ADDITION SQ. FT. CALCULATIONS

APPROVED
Limited building only review
Permit holder responsible for full compliance with the code

CRAWFORD RESIDENCE

PLAN NO.
CRAWFORD

ROOF PLAN
SCALE: 1/4"=1'-0"

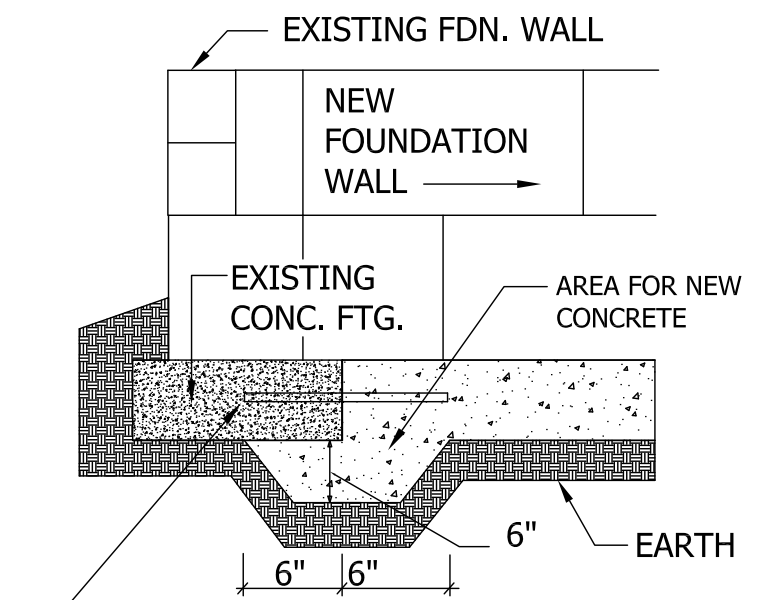
Provide ridge beam for cathedral ceilings, supported at both ends and designed to carry roof load
